## STAFF REPORT

SUBJECT: MCU-2021-0002  
Pine 43 Apartments – MCU

### I. PROJECT DESCRIPTION

## D. Proposed Landscape Plan, Open Space Plan (dated: 1/19/2021) & Amenity Detail

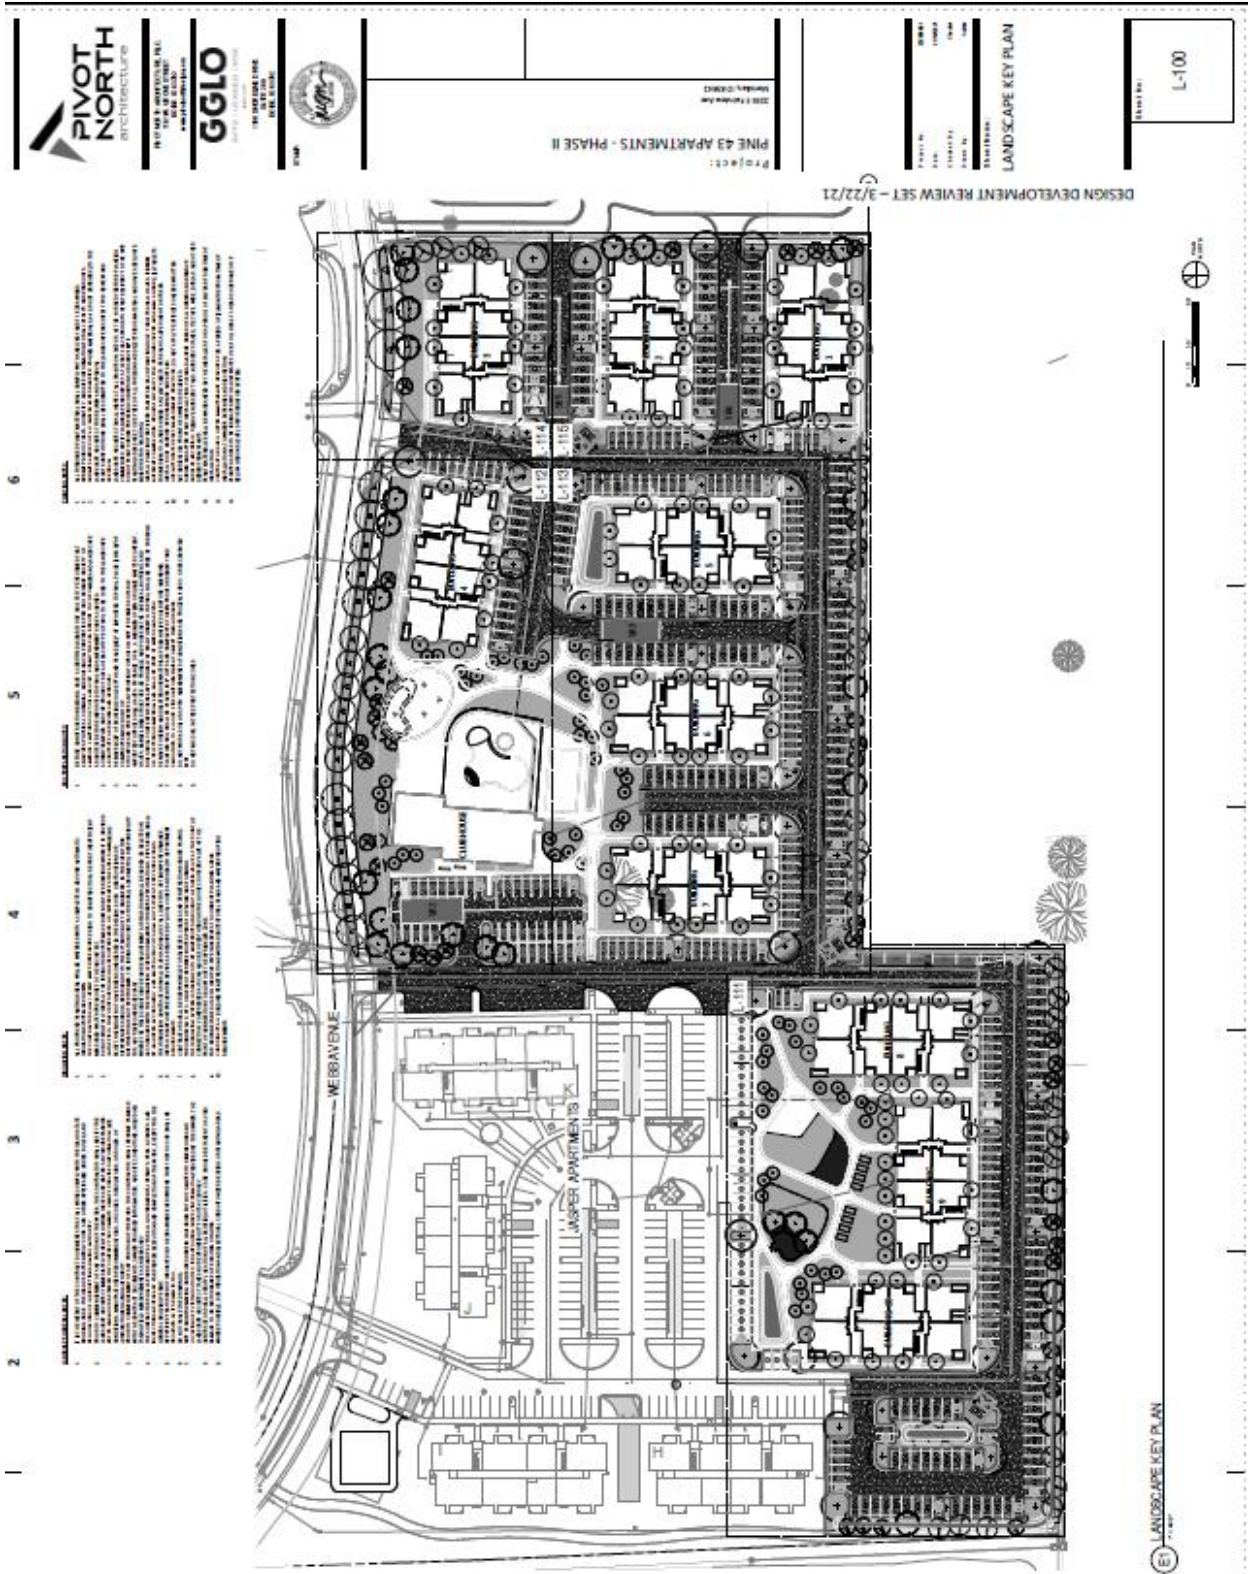
Fairly dense landscaping (approximately 1 tree per 25-linear feet) is proposed in the perimeter buffer along the eastern boundary of the site adjacent to parking and industrial uses to the east. **Staff recommends a mix of evergreen and deciduous trees, shrubs, lawn or other vegetative groundcover is provided in the buffer accord with the standards listed in UDC 11-3B-9C.1.**

Mitigation is required for any existing trees removed from the site per the standards listed in UDC [11-3B-10C.5](#); the landscape plan in Section VII.D depicts the existing trees proposed for removal. **Prior to removal of any trees from the site, coordinate with Matt Perkins, City Arborist, to determine mitigation requirements (208-371-1755).** Calculations should be included on the plan demonstrating compliance with UDC mitigation standards.

**Fencing:** All fencing is required to comply with the standards listed in UDC [11-3A-7](#). The Applicant states there is existing fencing along the project's east boundary that consists of a combination of chain-link and barbed wire; no fencing is proposed. **Because the garages have been removed from the plan that were previously proposed along the project's eastern boundary, Staff recommends a 6-foot tall closed vision/solid fence is provided along the eastern boundary, with landscaping as depicted on the landscape plan (approximately one tree per 25-linear feet and a mix of evergreen & deciduous trees), as a buffer.**

- l. Depict landscaping within the perimeter buffer along the eastern boundary of the site as proposed (i.e. a minimum density of one tree per 25-linear feet). A *mix* of evergreen and deciduous trees, shrubs, lawn or other vegetative groundcover shall be provided in accord with the standards listed in UDC [11-3B-9C](#).

## F. Proposed Conceptual Building Elevations & Perspective Drawings for Multi-Family & Clubhouse Structures

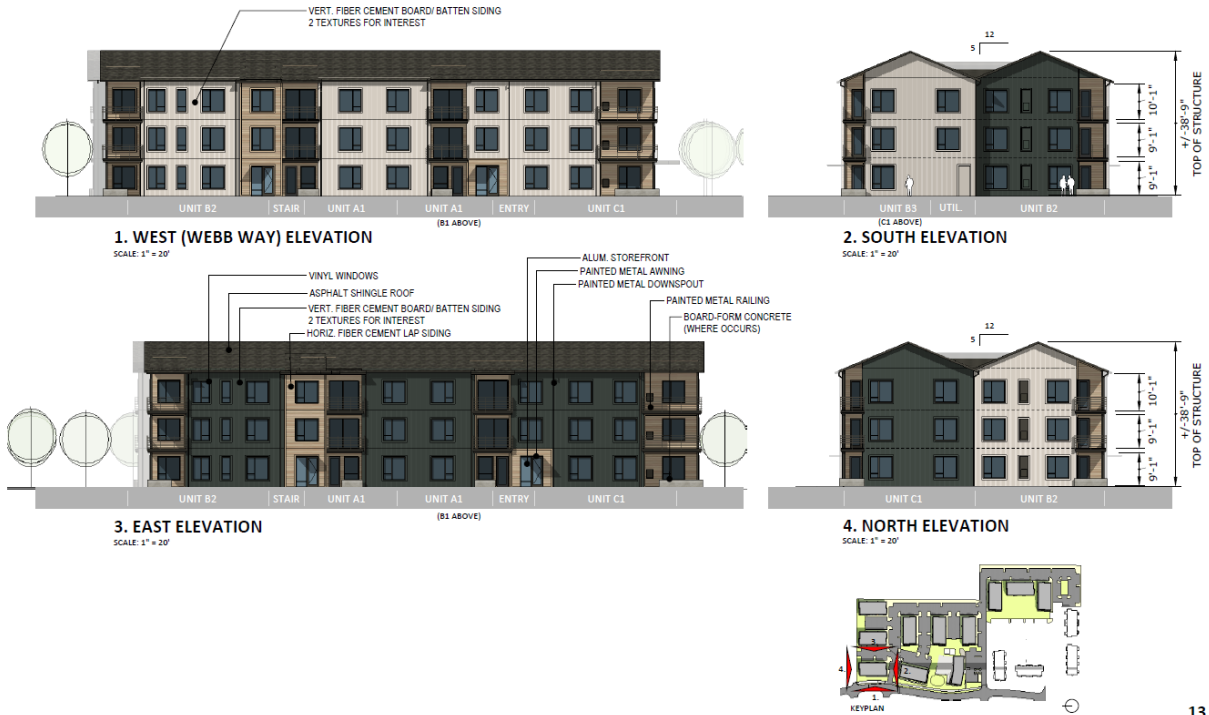
**Prefabricated steel siding is only allowed to be used as an *accent* material per the development agreement (see definition on pg. E-5 of the Architectural Standards Manual and #R5.1E) – revisions should be made to comply.** Additionally, per the DA, exterior building walls should demonstrate the appearance of high-quality materials of stone, brick, wood, or other native materials (acceptable materials include tinted or textured masonry block, textured masonry block, textured architectural coated concrete panels, or stucco or stucco-like synthetic materials – smooth faced concrete block, tilt-up concrete panels, or prefabricated steel panels are prohibited except as accent materials. The building design shall incorporate at least two (2) changes in one or a combination of the following: color, texture and materials. Rooflines shall demonstrate two (2) or more of the following: overhanging eaves, sloped roofs with two or more roof planes, flat roofs with varying parapet heights, or cornices.

**Administrative Design Review of the proposed structures is required. All structures shall comply with the design standards listed in the Architectural Standards Manual. The elevations submitted with this application are *not* approved and will likely require further modifications to comply with design standards.** Per the Architectural Standards Manual (ASM), architectural elements should be provided to clearly distinguish between the ground level and upper stories (ASM Goal #R3.1E); visually heavier and more massive elements or materials should be provided at the base of buildings with lighter elements and materials above (#R3.1F); horizontal and vertical elements should be integrated into facades to break up monotonous wall planes (#R3.20); 25% or more of the non-roof surface area of the clubhouse (i.e. accessory structure) must utilize a like material of the primary structures (#R3.3B); locate focal points as key elements within the building design to enhance architectural character (#R4.20); incorporate a trim color and an accent color or unique material into the color scheme as integrated details of the building design (#R.5.2A); modulate and articulate roof form of the clubhouse to create building profile interest and to reduce the appearance of building mass and scale (#R3.4).

12. All future structures shall comply with the design standards in the Architectural Standards Manual and in the [Development Agreement](#). Exterior building walls should demonstrate the appearance of high-quality materials of stone, brick, wood, or other native materials (acceptable materials include tinted or textured masonry block, textured masonry block, textured architectural coated concrete panels, or stucco or stucco-like synthetic materials – smooth faced concrete block, tilt-up concrete panels, or pre-fabricated steel panels are prohibited except as accent materials as set forth in the Development Agreement (provision #5.1.4h). *See notes in Section V under Building Elevations.*
